Value Engineering

Draft Report for Presentation

Removal of Elwha and Glines Canyon Dams, Elwha River Ecosystem and Fisheries Restoration Project

April 25, 2003

Figure 11. Gates

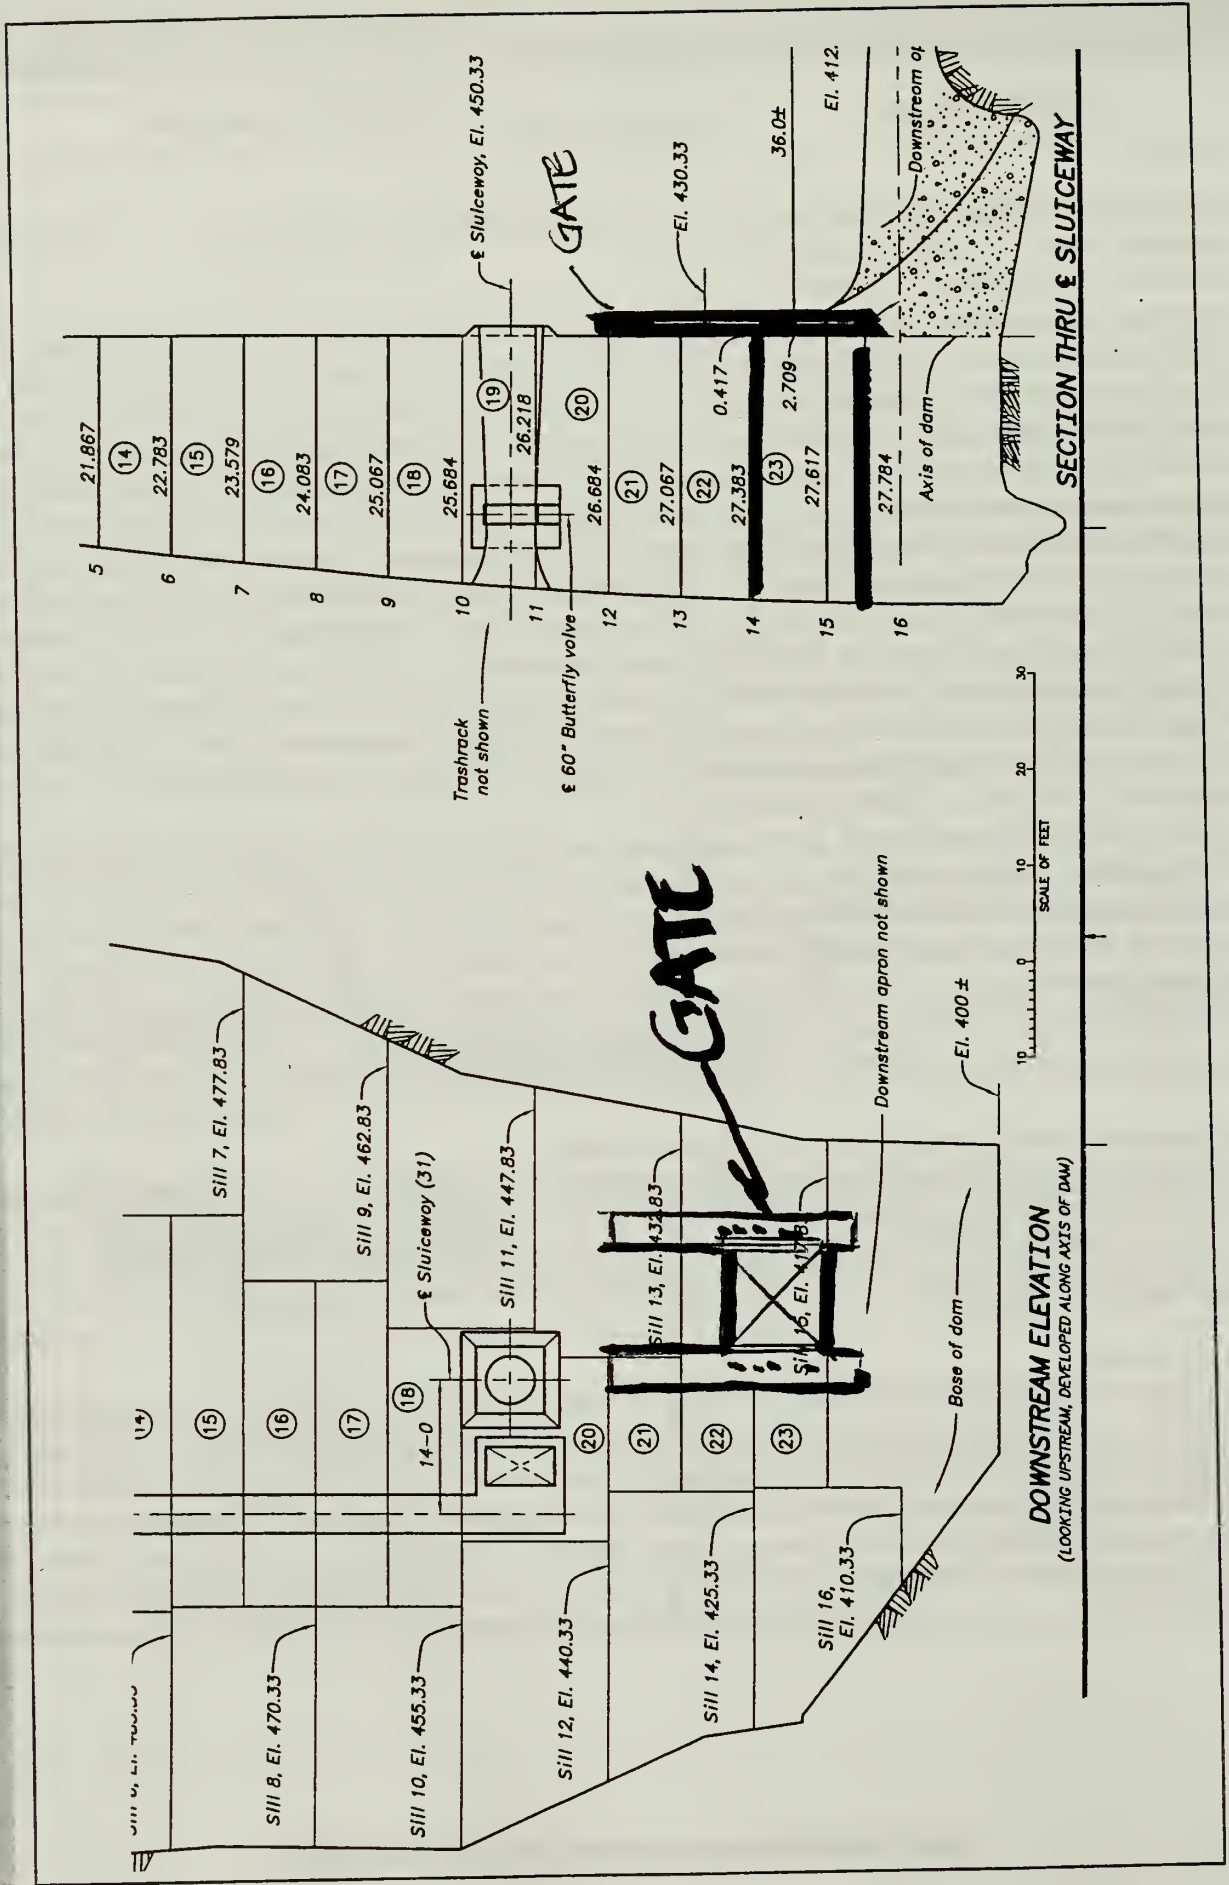
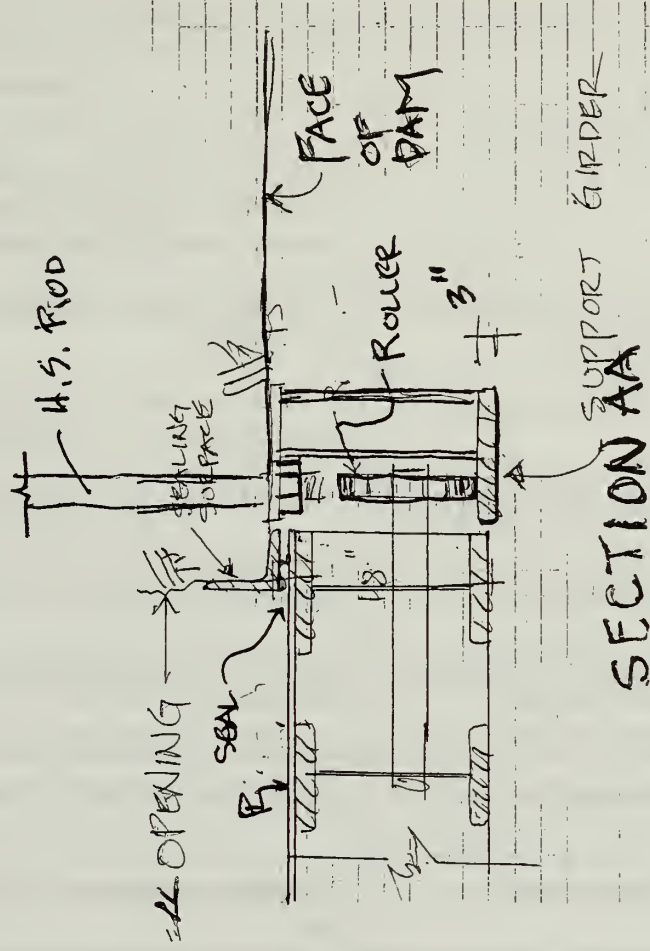
- Proposal Description: Construct low level outlet work with gate/valve control near the base of the dam at approximately elevation 425-430 ft. (see Figures 11 and 12 for one possible concept). Remove (dredge) sediment for approximately 200 ft. upstream of the dam prior to daylighting through the upstream side. Draw down Lake Mills and redistribute and release sediments using existing spillway, penstock, and low level outlet to elevation ~425 ft. following decommissioning of Glines Canyon powerplant approximately one year prior to dam removal. Each drawdown increment to elevation 470 ft. will be 10 ft. followed by 10 days to 2 weeks at constant elevation to facilitate sediment redistribution. Following sediment redistribution to elevation 470 ft. refill Lake Mills. Upon removal of Elwha Dam to elevation 110 ft. resume and complete drainage of Lake Mills. Drawdown below elevation 470 ft. will be at rates that accomodate downstream fish management, and sediment delivery and transport objectives. Dam demolition will commence following drawdown of the reservoir and will proceed at maximum rates unconstrained by fish or sediment management considerations.
